CITY OF FRANKLIN PLAN COMMISSION MEETING* FRANKLIN CITY HALL COUNCIL CHAMBERS 9229 W. LOOMIS ROAD, FRANKLIN, WISCONSIN AGENDA THURSDAY, APRIL 21, 2022, 7:00 P.M.

1. FIDUCIARY REAL ESTATE DEVELOPMENT, INC. MULTI-FAMILY APARTMENT COMPLEX WITH A CLUBHOUSE DEVELOPMENT.

Project Name:	The Seasons at Franklin
Project Location:	9801 South 27 th Street, 9605 South 29 th Street (Tax Key No: 902-9965-006 & 902-9966-001)
Property Owner:	CCM-9801 27 th Franklin LLC
Applicant:	Fiduciary Real Estate Development, Inc.
Agent:	Anthony DeRosa, Fiduciary Real Estate Development, Inc.
Current Zoning:	B-4 South 27th Street Mixed Use Commercial District
2025 Comprehensive Plan:	Mixed Use and Areas of Natural Resource Features
Applicant's Action Requested:	Recommendation to the Plan Commission for approval of the Natural Resource Special Exception Application
Planner:	Heath Eddy, AICP, Planning Manager

Date:	April 7, 2022
To:	Heath Eddy, AICP, Planning Manager City of Franklin, Department of City Development
From:	Anthony DeRosa, Fiduciary Real Estate Development, Inc
RE:	Response for Natural Resource Features Special Exception (NRSE) application, 9801 South 27 th Street/9605 South 29 th Street (TKNs 9

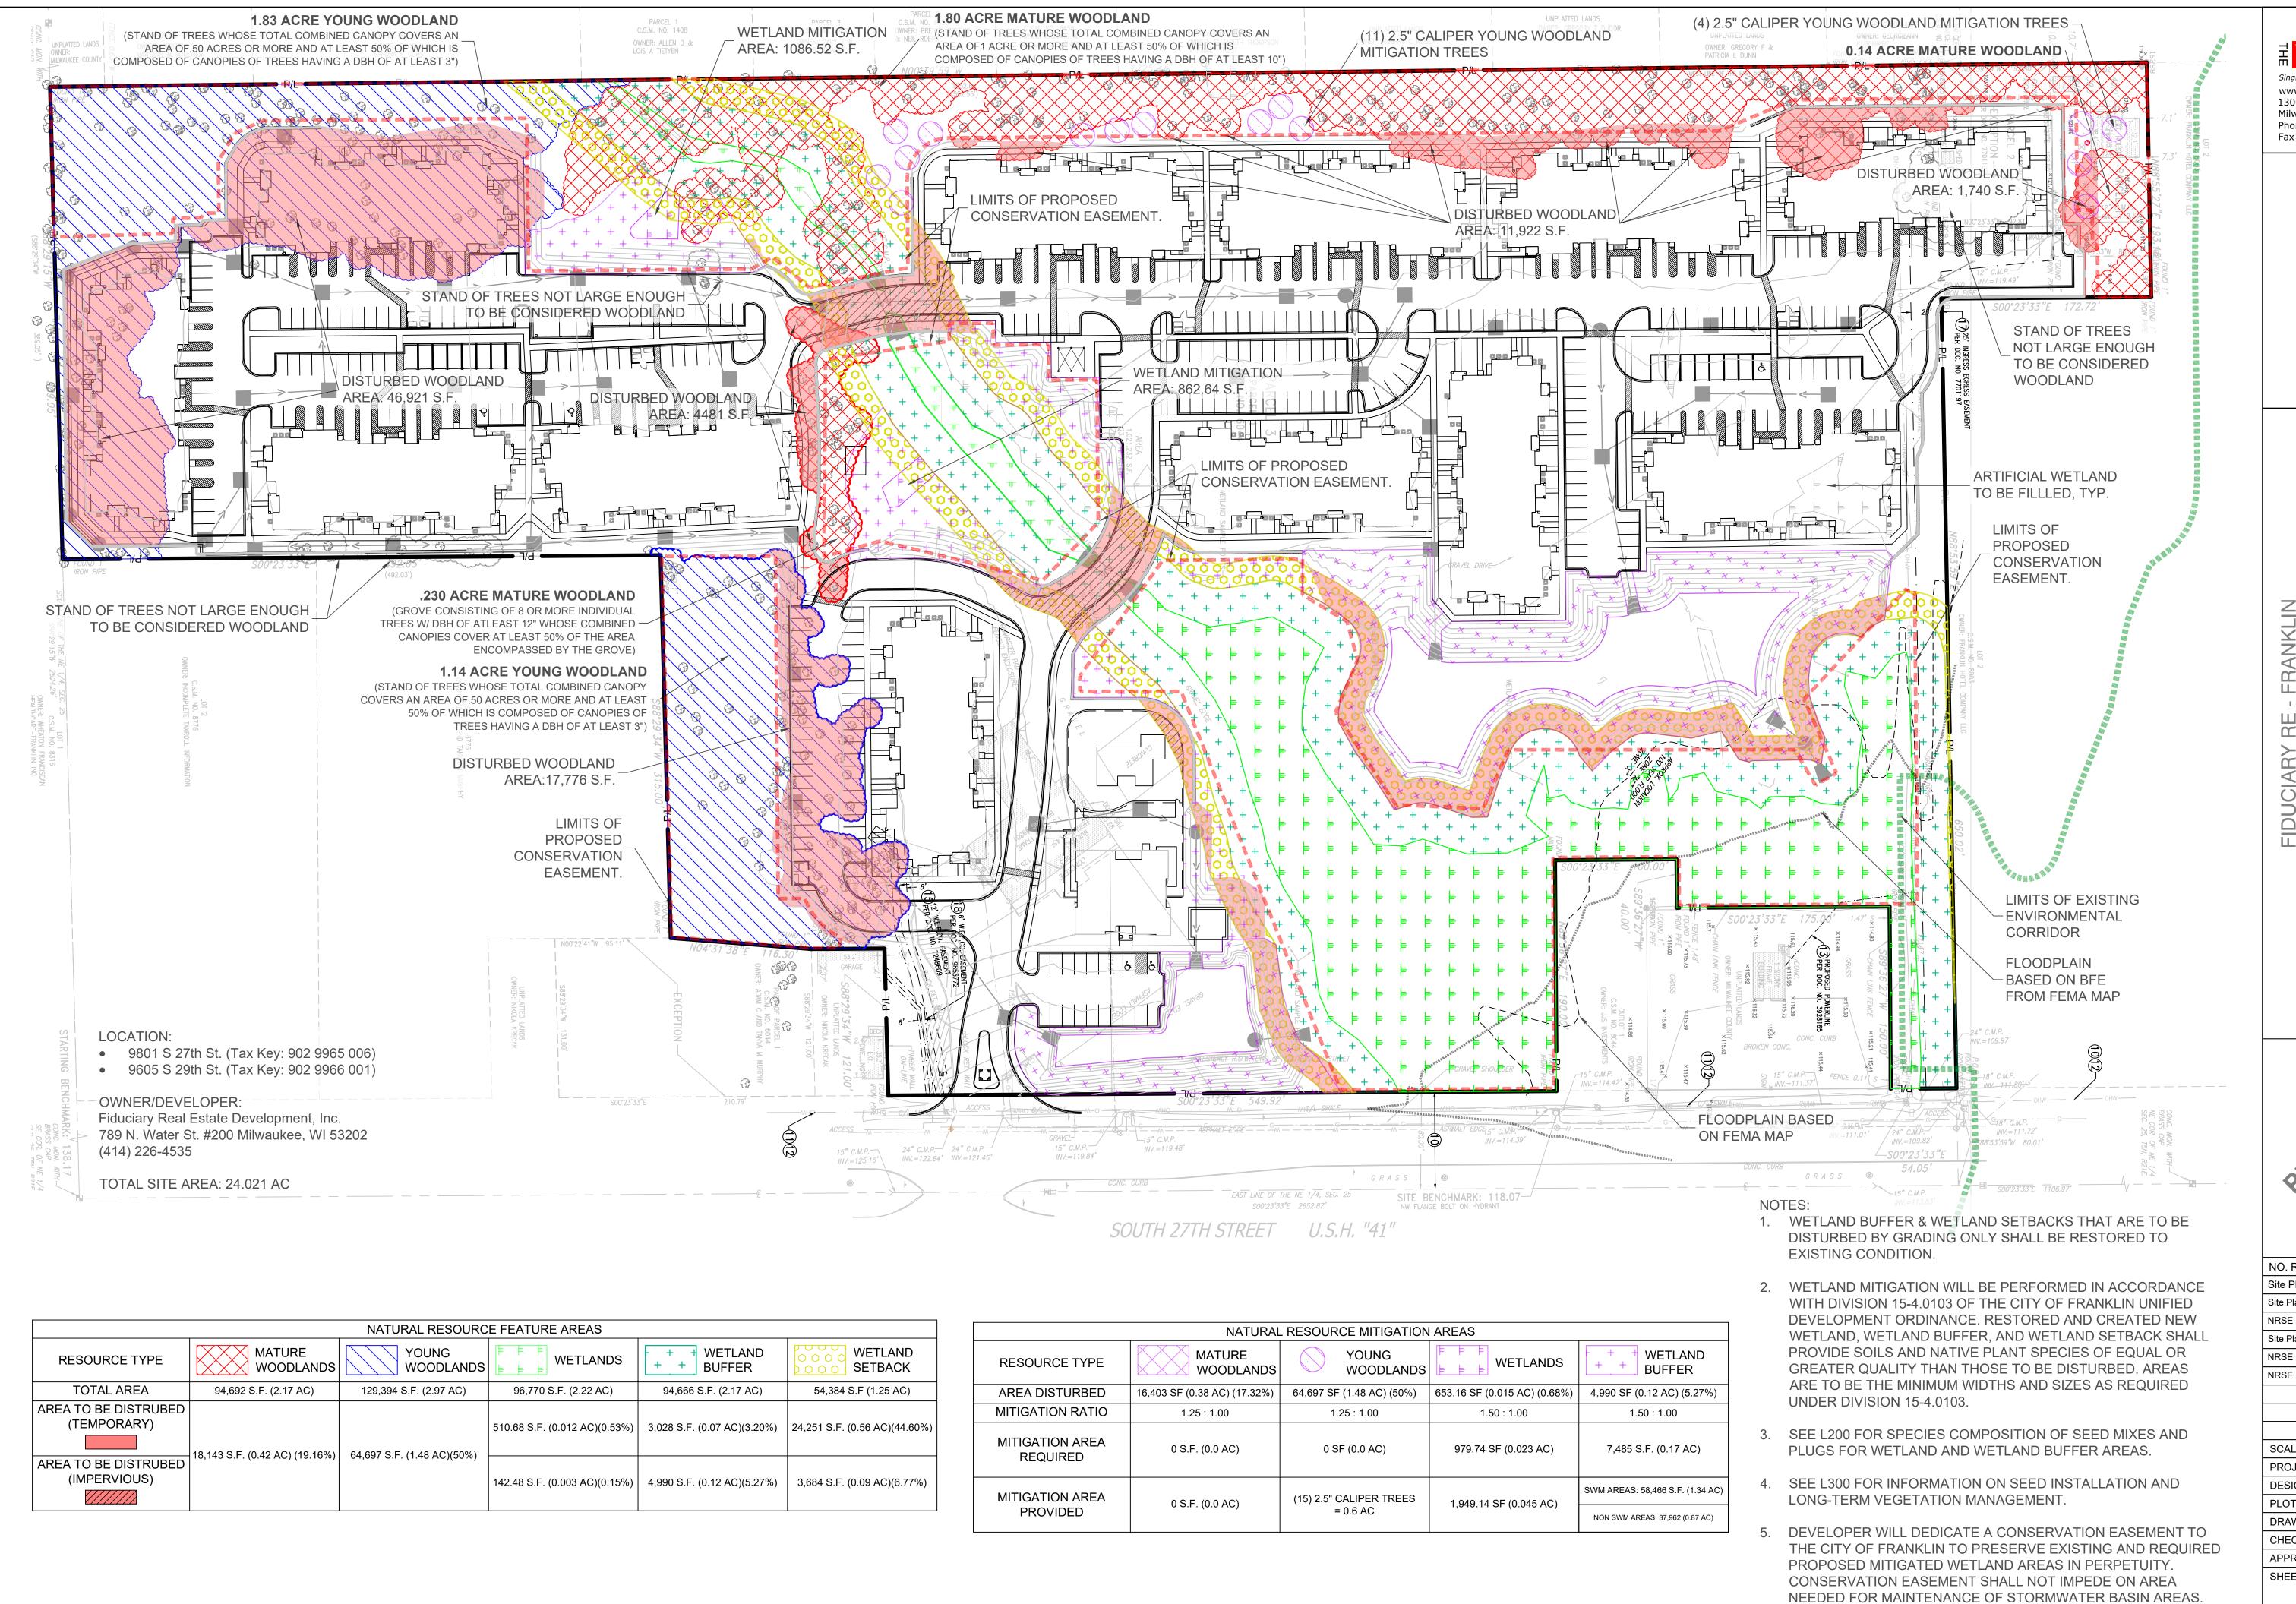
- 1. Application Form. No comments. Form includes all elements as required.
- 2. Legal Description. No comments.
- 3. **NRPP.** The submitted NRPP shall comply with UDO §15-7.0201. The following items are missing and shall be placed on a revised NRPP to be provided to the Department of City Development:
 - a. Location The location of the proposed development (Address and Tax Key Numbers) This has been added to NRPP
 - b. Names, Address and Telephone Numbers of Owner and Developer.

- c. Date all dates of submittals of the NRPP, including a list of all revision dates.
 This has been added to NRPP
- d. Site Boundary specifically, total land area encompassed by the site.

f. Method of Natural Resource Preservation – graphic illustration and notes relating to how natural resource features, which are to be preserved, will actually be preserved in perpetuity. There is a general statement indicating perpetual preservation, but no method assigned. Note: City policy typically is a Conservation Easement dedicated to the City, for both existing resources and areas of proposed mitigation. We've added in proposed extents of a conservation easement around natural resource areas to be protected in perpetuity and have ensured no conflicts with areas that will require access for continued maintenance.

- g. Location of the Secondary Environmental Corridor located immediately north of the site. This is on the NRPP
- 4. **Mitigation Proposed.** Staff reviewed the proposed planting schema and soils combination and finds them generally suitable. Of note, however: the bulk of the 99,185 square feet of the Wetland Buffer mitigation area is surrounding the two primary stormwater basins. Normally the City requires mitigation areas to be placed under perpetual protection (i.e. Conservation Easements, in favor of the City), and this could create a repeated conflict with the maintenance of the stormwater basins as located and designed. The applicant should consider some method to ensure these conflicts can be resolve operationally so the City and the operator (successors and assigns) don't run into repeated interpretative issues and conflicts going forward. **ALSO, please provide an estimate of the amount of proposed Wetland Buffer mitigation around the stormwater basins and the amount proposed elsewhere**.

- ii. B.-
 - 1. It should be noted that the WDNR General Permit is for 653 square feet of wetland disturbance, so there is a disconnect here. Staff has requested clarification from Ryan Pappas regarding the number, since they also refer to the approval as 0.015 acres (which could also be 671 square feet), and we want to verify which number is the actual limit of fill/disturbance that matters.

This has been added to NRPP

This has been added to NRPP

We've added in proposed extents of a conservation easement around natural resource areas to be protected in perpetuity and have ensured no conflicts with areas that will require access for continued maintenance. Mitigation areas within the conservation easement exceed City of Franklin required area mitigation areas.

The correct number is +/- 653 square feet. See NRPP.
